Service Bulletin B787-81205-SB320028-00 LANDING GEAR - PARKING BRAKE SYSTEM - Parking Brake and Alternate Pitch Trim Module Change

Publication:	B787-81205-SB320028-00	Issue 001, 31 Oct 2016

Figure 1

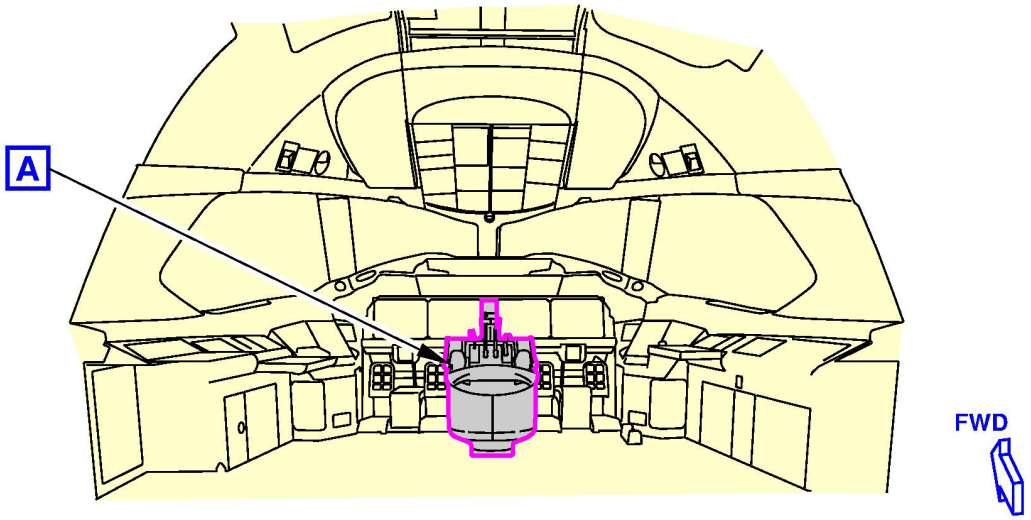
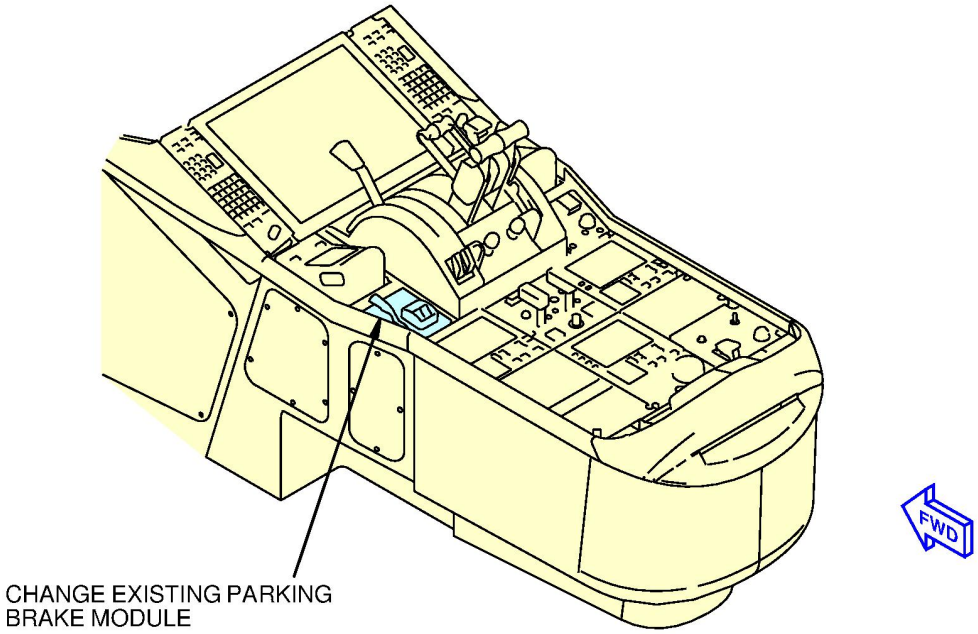
This service bulletin is sent to instruct operators to install the new Parking Brake and Alternate Pitch Trim Module (PBM). The current PBM may be unintentionally disengaged, fail to set, fail to release, or become jammed. The new PBM cannot be disengaged without depressing the brake pedals, will incorporate changes in the assembly that eliminate jammed solenoid errors, and will introduce a better design. If the changes in this service bulletin are not done, operators may experience error messages, jammed PBM solenoid, unintended parking brake release, and may be unable to set or release the parking brake, which could result in damage to the airplane and hazards to persons or property on the ground.

The 787 fleet has experienced in-service delays due to reliability issues with the current PBM. It is possible for the parking brake to release from the set position without depressing the brake pedals if the lever is bumped. Difficulty setting the parking brake has occurred when the timing between pulling the lever and depressing the brake pedals is not correct. It is also possible for the brakes to remain set after the lever has returned to the released position. Any of these conditions may occur without a maintenance message.

The new PBM will reduce friction in the assembly to allow the solenoid to retract under all pilot loads. Improved design in the new PBM will eliminate the 32-38007 maintenance message due to switch hysteresis. The new PBM will also increase the parking brake lever travel before the interlock is encountered, to increase the timing margin to engage the parking brake when the pilots pull on the lever as they push on the brake pedals. This change will make setting the parking brake on the 787 more like the 777 operation.

Replace the Parking Brake and Alternate Pitch Trim Module (PBM).

NOTE: Parking Brake and Alternate Pitch Trim Module (PBM) 4260-0037-5 is obtained by removing the existing PBM and sending the unit directly to the supplier. As an alternative, new PBM can be obtained directly from the supplier.
